TRANS/WP.29/GRB/2005/2/Rev.2
6 July 2005

REVISED PROPOSAL FOR DRAFT AMENDMENTS TO REGULATION No. 51
(03 series of amendments)

(Sound emissions of M and N categories of vehicles)

Transmitted by the GRB Informal Group

EXAMPLE FOR MEASUREMENT PROCEDURE FOR VEHICLES OF CATEGORY N2, M2 > 3,500KG, N3, M3

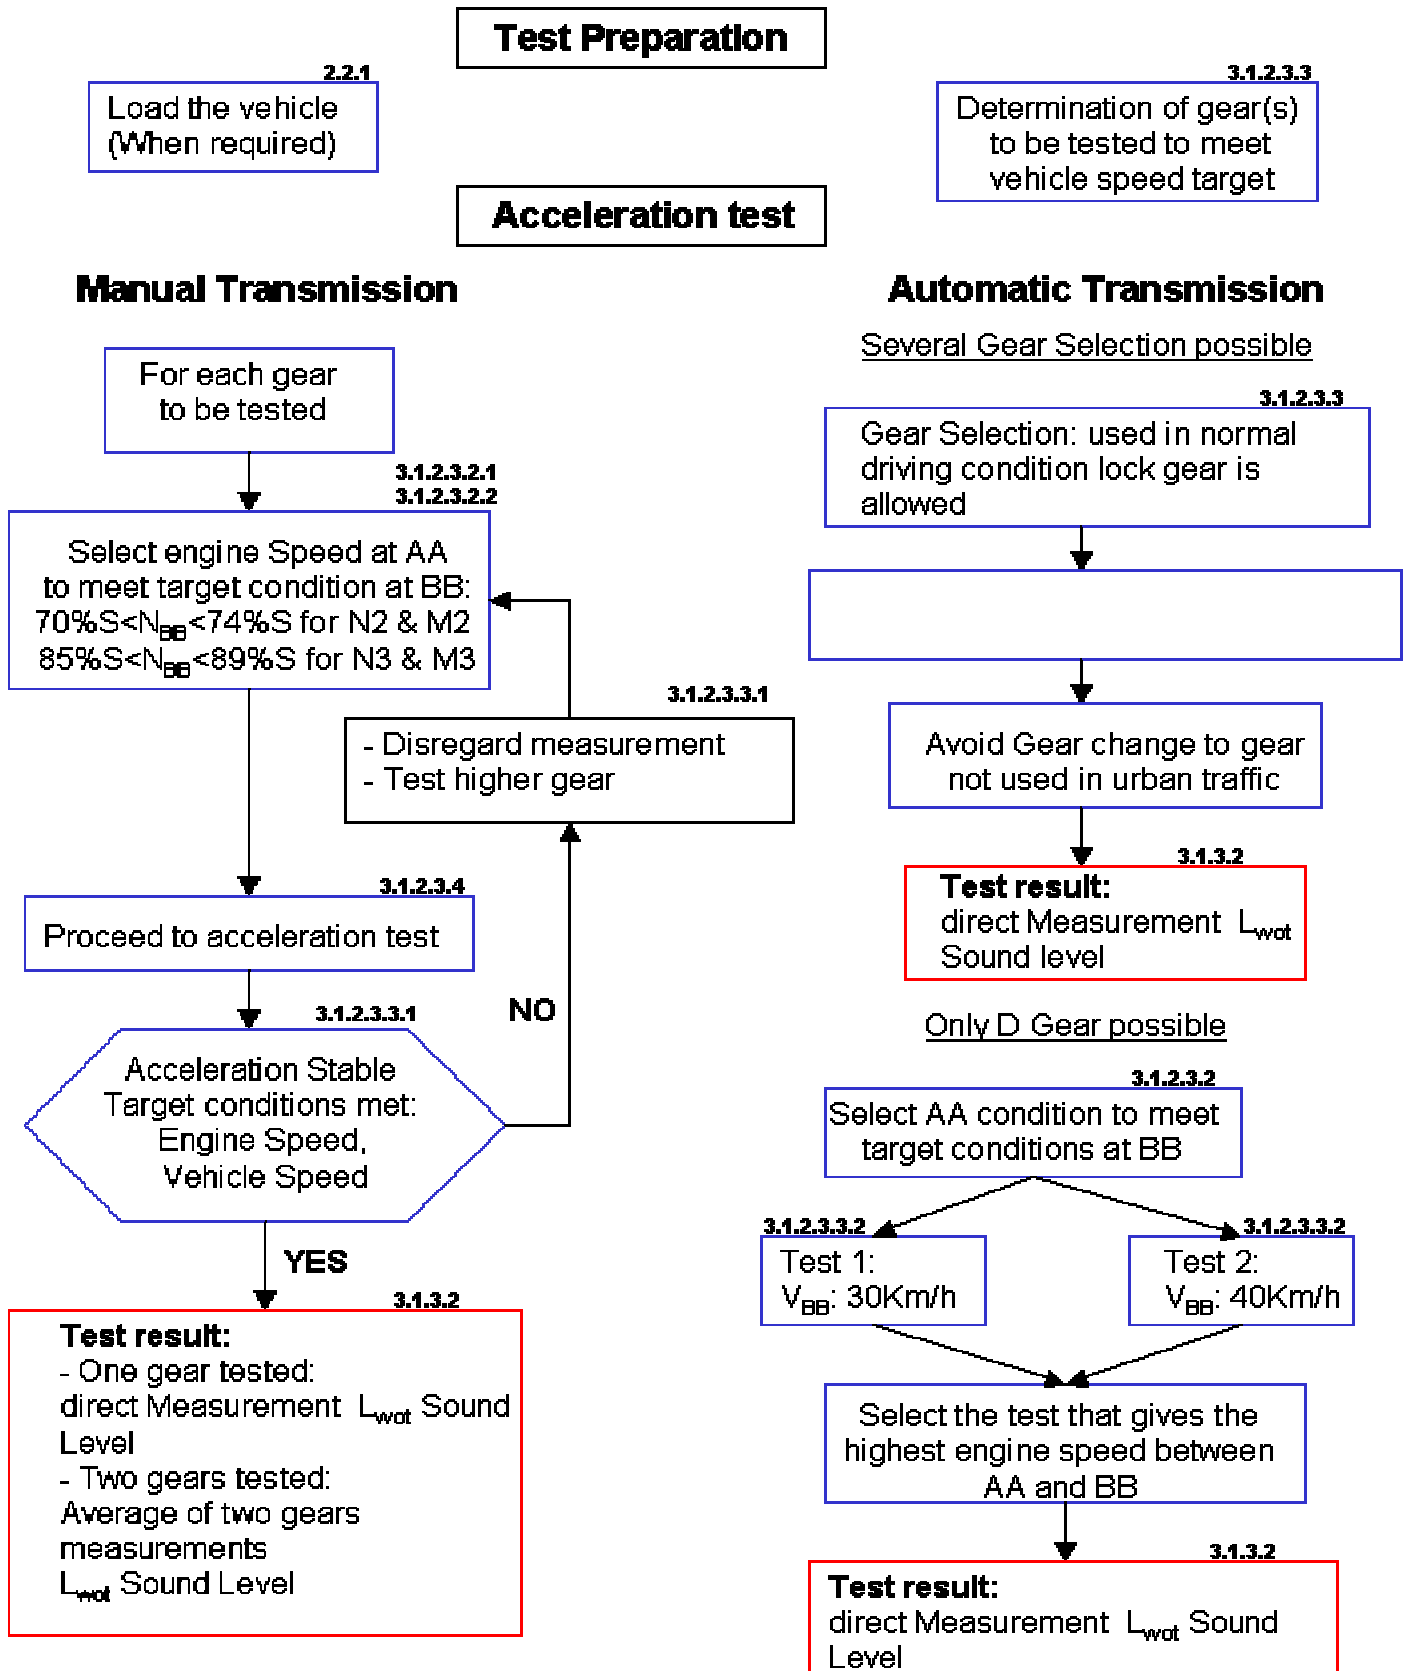
[needs to be updated]
